Henkel Adhesive Material Conversion for Commercial (XC) and Defense (XQ) Devices

XCN26002 (v1.0) April 13, 2026 | Product Change Notice - FYI

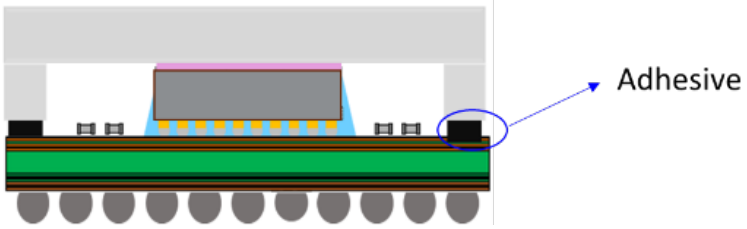
AMD supplier Henkel has discontinued the supply of adhesive material effective January 2026 due to the discontinuation of raw material manufacturing. To address this change, AMD will transition legacy Commercial (XC) and Defense (XQ) products that use Henkel to an alternative adhesive supplier. This alternative adhesive has been used in other AMD products for several years without any supply or quality concerns. This change ensures supply continuity for legacy XC and XQ flip-chip BGA packages.

There are no changes to fit, form, function, reliability, or MSL rating of the packages.
